# Access Compliance Report

### (Curb Ramps)

Intersection ID: 45487	Main Street: WADE_ARDREY_RD	Cross Street: CAPTAIN_ARDREY_RD	Location: SE
ADA ID: 6BA3A4C66976	Ramp Type: PerpDiag	Initial Pass/Fail: Fail	Overall Compliance: No
Severity Score: 10			
Codes/Mitigation Info/Possible Solution		Field Measurements/Component Compliance

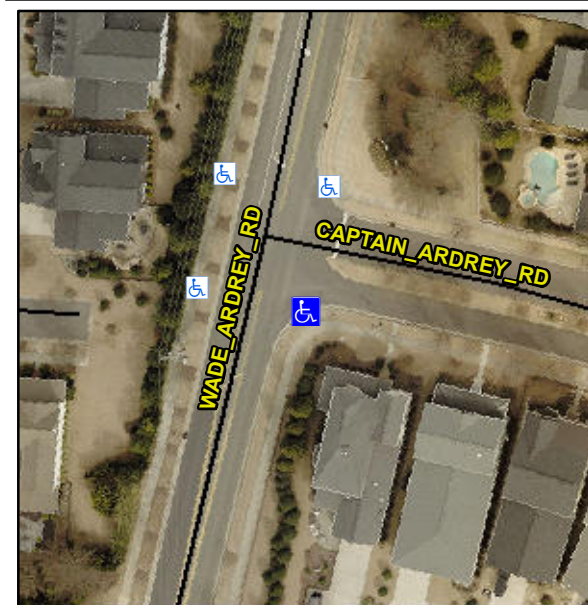
**Remove & Replace Curb Ramp With Two New Directional Ramps or Equivalent.**

**Not Found, R304.5.1, R304.5.3**
